**MINUTES
BOARD OF BUILDING STANDARDS/
ARCHITECTURAL BOARD OF REVIEW/SIGN REVIEW
REVIEW MEETING
CITY OF LAKEWOOD
12650 DETROIT AVENUE
AUDITORIUM
AUGUST 8, 2024
5:30 P.M.**

**Irene & Donald Ave.
Thoreau & Donald Development**

Applicant proposes a planned development consisting of seven townhouse units and three single-family houses. (Page 4)

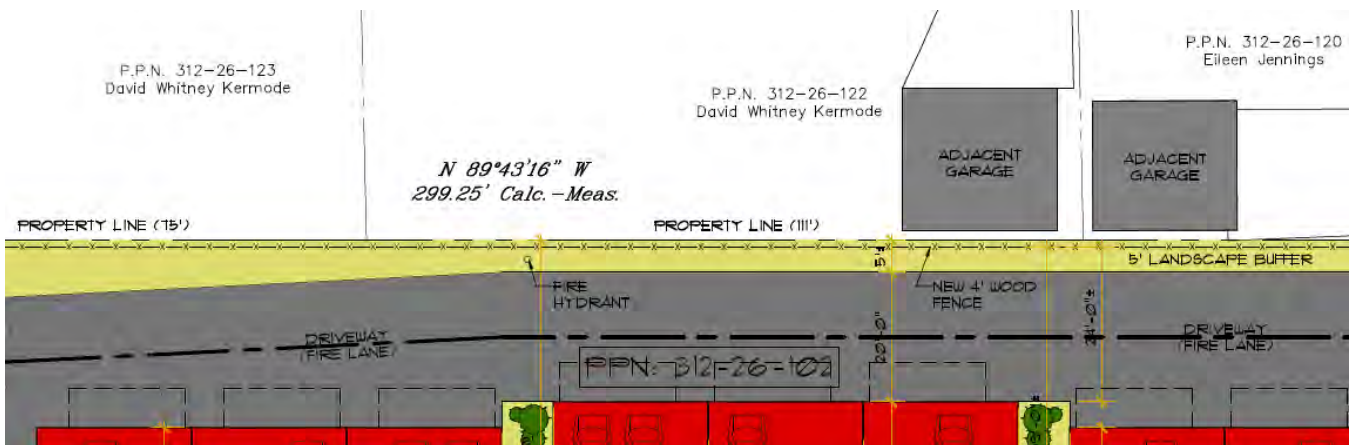
- The proposed five foot grass strip along the northern property line adjacent to the proposed 20' wide through roadway is wholly inadequate for any meaningful screening. Further, the plans as presented appear to lack any planned landscaping apart from a four foot fence and grass seed for the strip between the proposed roadway and the northern property line. A four foot fence won't serve as any impactful screening from north facing building lighting, HVAC units located outside the ground floor doors on the north, headlights and taillights from the 11 north facing garage bays, and general vehicle traffic from a new east/west 20' wide through roadway from Donald Avenue to Thoreau Road.

The limited setback and close proximity of the proposed roadway needlessly places the onus of any required screening on adjacent property owners. With the introduction of vehicle access for 11 new residences, including waste removal and service/seasonal plowing vehicles, introduces wintertime road salt to already installed landscaping by adjacent owners that would require seasonal protection such as burlap wrapping to protect against detrimental impacts of road salt not currently necessary.

Architectural Site Plan

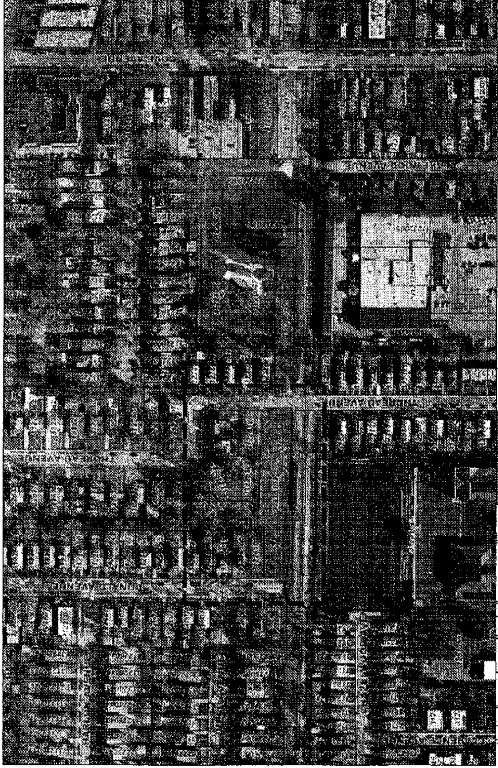
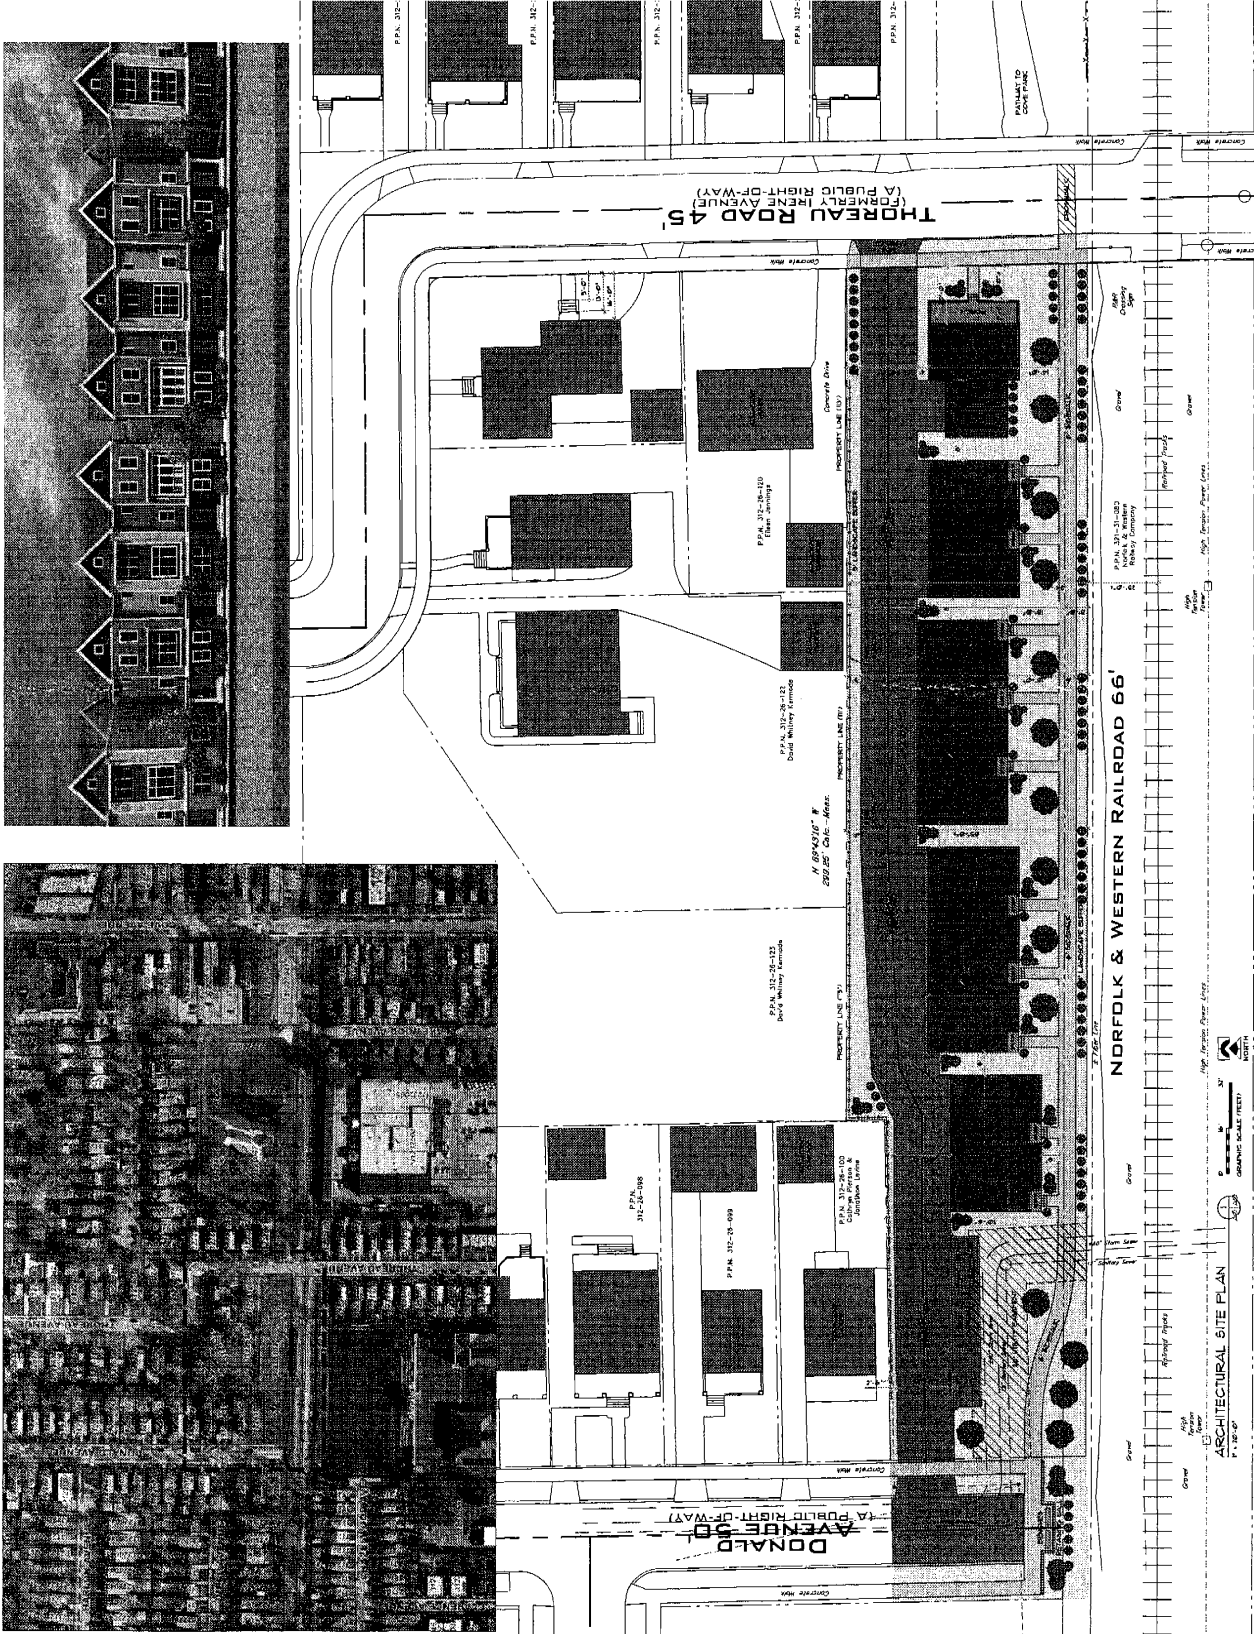
- The updated plans continue to offer no acknowledgement of the existing site topography, which slopes downward from southeast to northwest. The site plan offers no indication of any necessary retention walls to support the proposed 20' roadway, other necessary grading or planned site drainage. Lack of detail regarding necessary retention walls, site grading and drainage makes any fuller assessment of resulting impact to adjacent properties impossible as presented.

- The site plan as rendered does not allow for any plantings with height (five feet of grass strip with the rest being pavement up to the building face), leaving the under detailed façade exposed in near perpetuity
